V5_Drainage letter_comments.pdf Markup Summary

**FINAL DRAINAGE REPORT
LOT 2, BENT GRASS EAST COMMERCIAL FILING NO. 4
CARUBIA PROPERTIES**

PCD FILE NO. PPR256

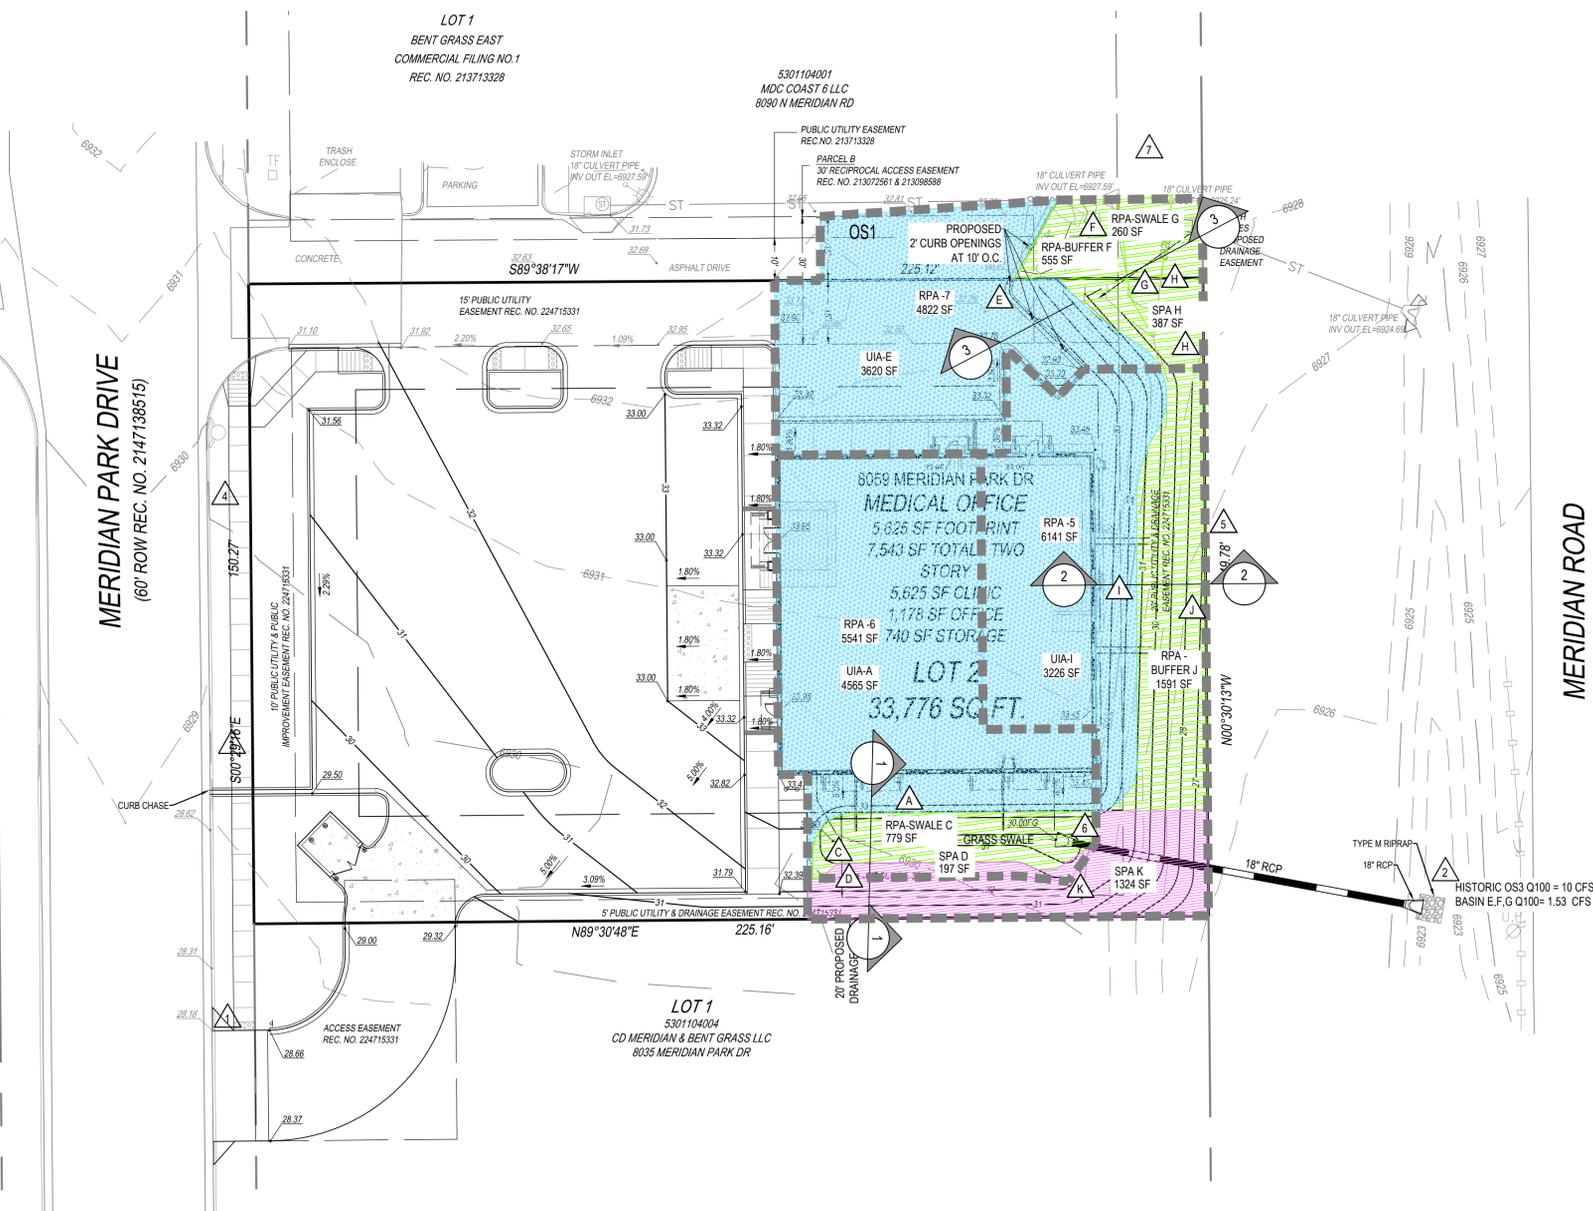
Please update this sheet per all of my comments in the duplicate sheet in the CDs.

See cds for responses.
